CANYON FUEL COMPANY, LLC

DUGOUT CANYON MINE METHANE DEGASSIFICATION AMENDMENT Well G-29

RE: Addressing Deficiency List, Task No. 3400, Revisions to Degas Well Amendment to Add Degas Well G-29, Dugout Canyon Mine, Canyon Fuel Company, LLC, C/007/039, Carbon County, Utah

FIGURE 1. CONTOUR MAP FOR G-29

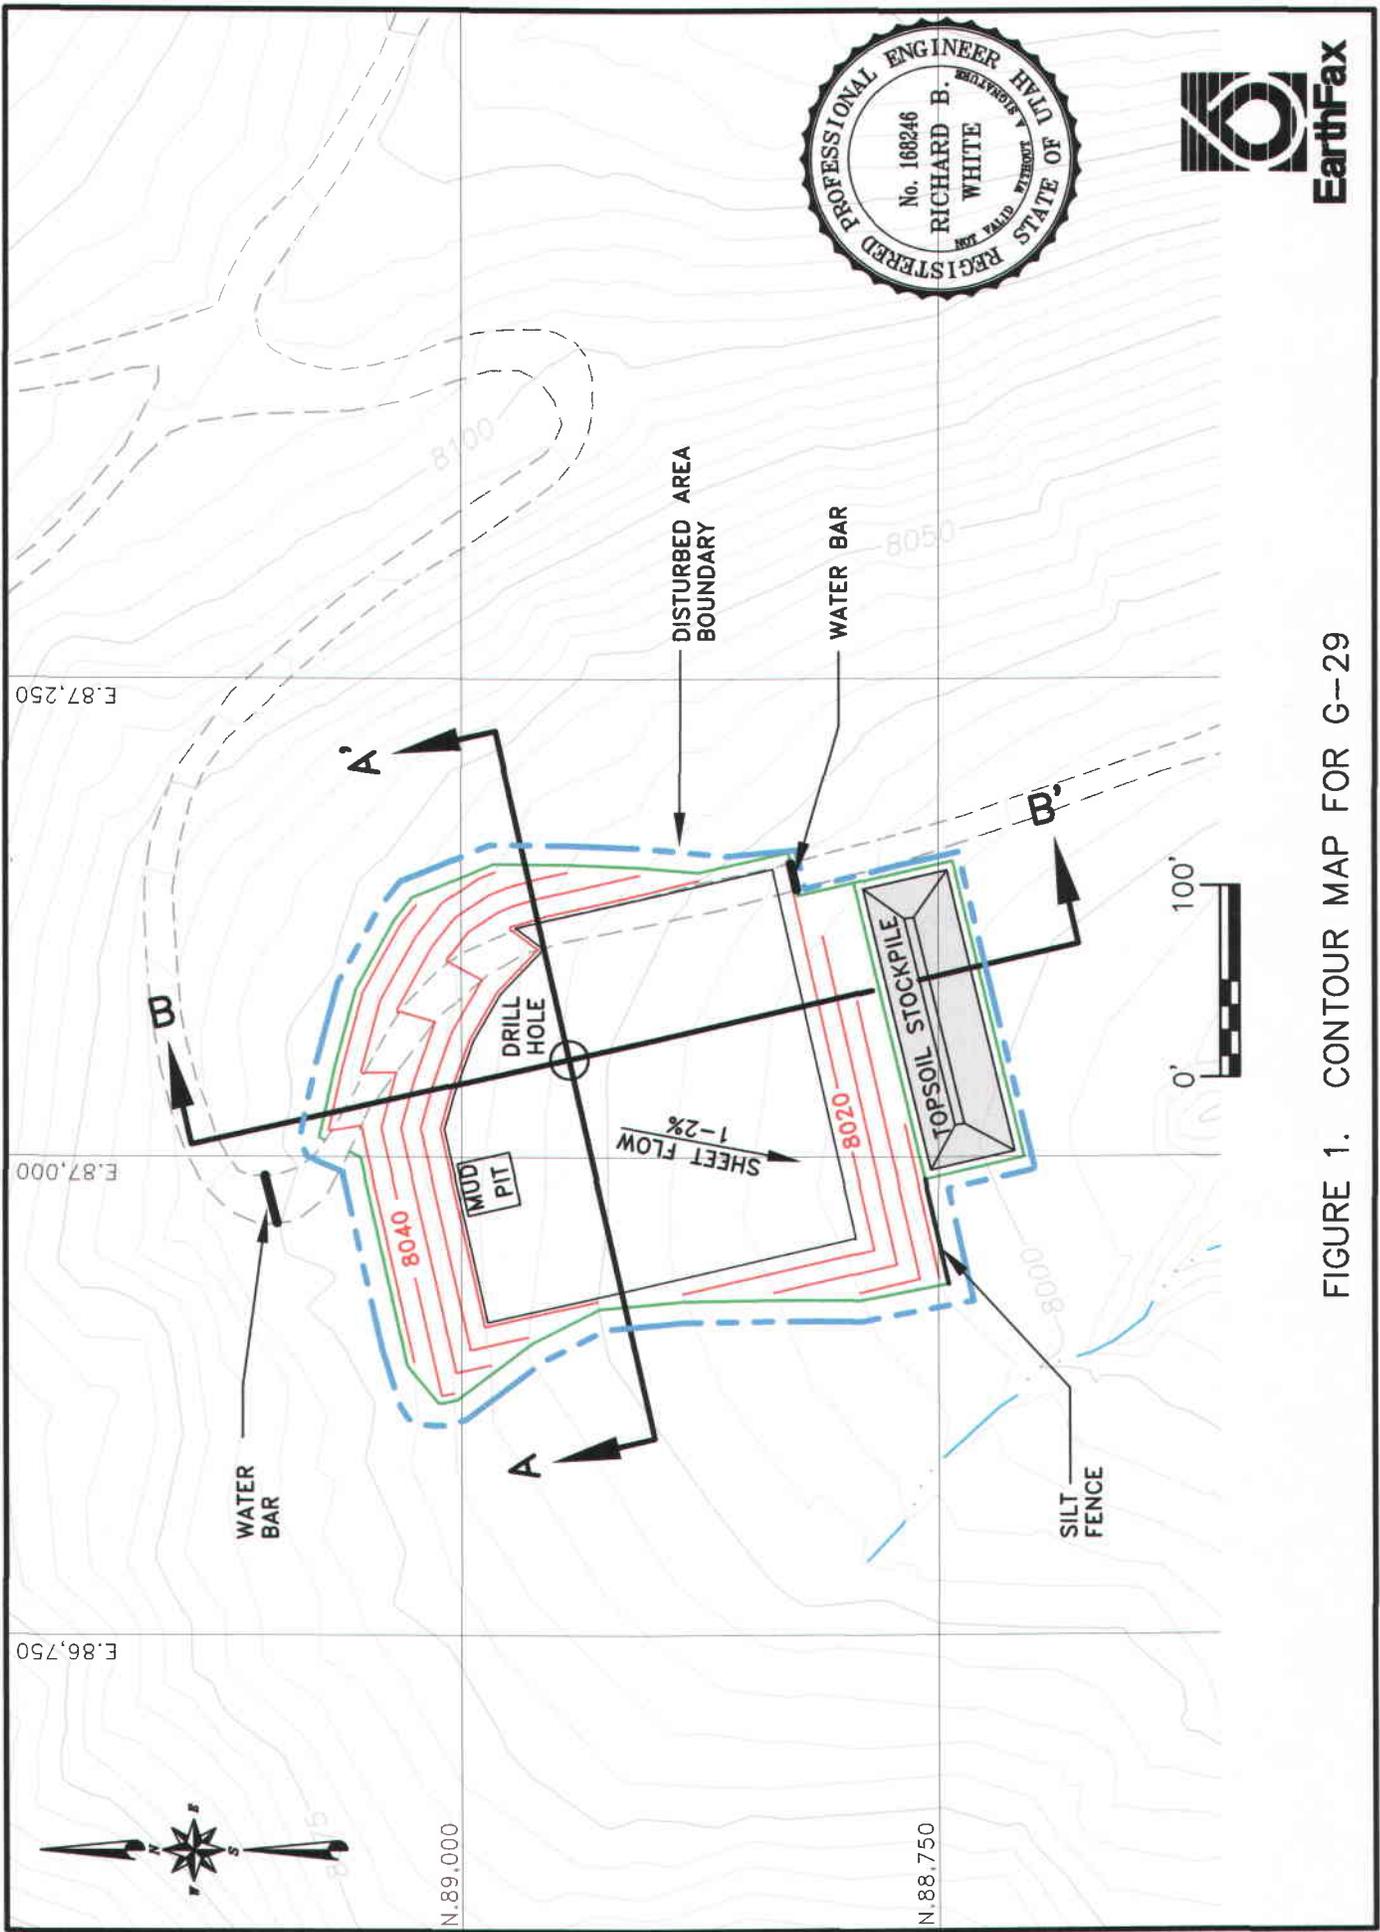
R645-301-724 – The characterization of the nature of the drainage located adjacent to Degas Well pad G-29 is provide in Section 724, Page 7-4 as has a reference to where Figure 1 is located in the permit.

slopes to the southwest predominately covered with sagebrush. As shown on Figure 1, Contour Map for G-29 (Attachment 5-1) there is a drainage located southwest of the pad. In the description of the G-26 pad a severely eroded slope on the east is described as the top of a small ephemeral drainage, this same drainage continues from the area of the G-26 pad and runs parallel to the southwestern corner of the G-29 pad. The drainage is approximately 100 feet from the southwest corner of the pad's disturbed area boundary. Water has never been observed by the permittee in this drainage.
